Product Change Notification

Product Change Notification: E-16-014615

AMPMODU MTE HEADERS GPL 296

Change in circuit cavity features

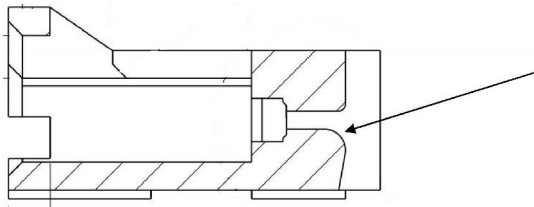
To satisfy customer demand for the capability of MTE headers to handle RoHS solder temperatures, TE Connectivity has retooled the MTE header product line to use high temperature compatible LCP molding material. These changes will result in the following product changes: 1) Housing material will change from high temperature nylon to LCP. 2) The header housing width will be reduced by 0.005 inches to accommodate the assembly process. 3) In order to consolidate some housing features, the contact cavity configuration will be changed slightly as shown in the attached sketch.
